UNITED STATES PATENT AND TRADEMARK OFFICE

Office Action Summary	Application No. 10/767,459	Applicant(s) ANDERSON ET AL.	
	Examiner Henry M. Johnson, III	Art Unit 3739

DETAILED ACTION

Fig. 2B

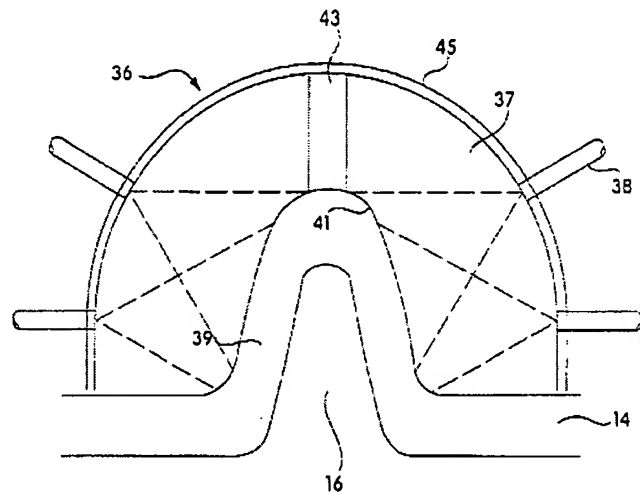
Claims 1-3, 6-15, 16-18, 20-25, 27, 29, 30, 46, 47, 49 53-55 are rejected under 35

U.S.C. 102(e) as being anticipated by U.S. Patent 6,605,080 to Altshuler et al. Altshuler et al.

teaches methods for treating tissue with electromagnetic radiation wherein tissue (Fig. 2B, # 39) is

positioned near radiating elements (Fig. 2B,

38) and irradiated via the elements.

Tissue is drawn into the handpiece via a

suction port (Fig. 2B, # 43), the tissue being

pinched and folded in the process (Col. 13,

lines 35-36). It is inherent that the tissue is

also stretched as it is sucked into the

device. The radiating element receives
